CLIMATE CONTROL RETURN AIR GRILLE

Return Air Grille Service Bulletin

| Model | Serial Number Range |
|---------------------------|--------------------------|
| Dometic Return Air Grille | 3315910.012, 3315930.010 |

Gap present

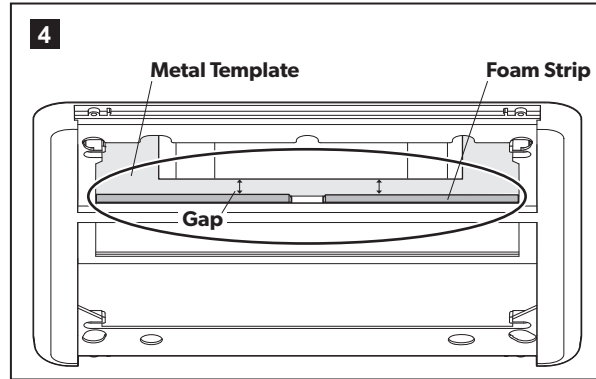
i If a gap is present between the foam and metal ceiling template, the foam installation must be reworked. Refer to section "2 Reworking the foam installation."

2.2 Installing the new foam barrier

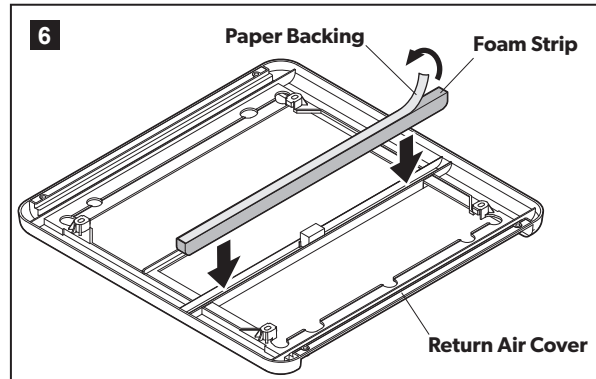
Dometic return air grilles have an issue with the foam barrier that separates the discharge air from the return air for the A/C unit. A non-conforming foam barrier creates a gap between the grille shell and the ceiling template. This gap results in a loss of A/C efficiency, with significantly lower air flow delivered to the ducted vents, and has the possibility of freezing the evaporator coil in hot, humid environments. To solve the problem, the appropriate foam must be installed on top of the non-conforming foam to properly seal the gap between the grille shell and the ceiling template.

i Only use the foam specified (service kit part number 31375). This Foam is UL94V-0 rated for use in HVAC systems.

- Cut the foam to a length of 16.75".
- Peel back the paper to expose the adhesive and apply the foam directly to the top of the existing foam barrier.
- Reinstall the grille shell. There should be no gaps between the grille shell and the ceiling template.
